**0CAN012402**

**Summary of Changes to the ANO Emergency Plan, Revision 50**

**Arkansas Nuclear One Emergency Plan, Revision 50**

**Revision 050**

**FIGURE M-1**  
**Corporate Positions**  
**Assigned Recovery Responsibilities**

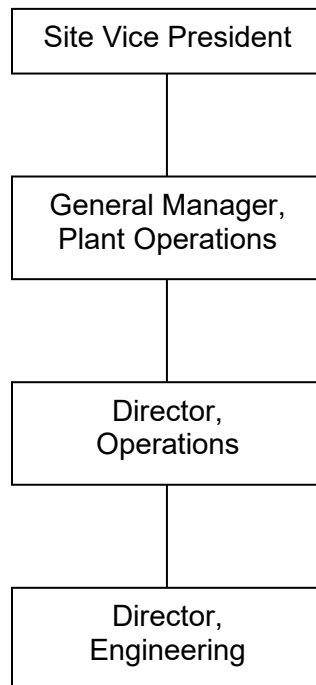
Page M-5, Figure M-1,	Changed Manager, Operations to Director, Operations
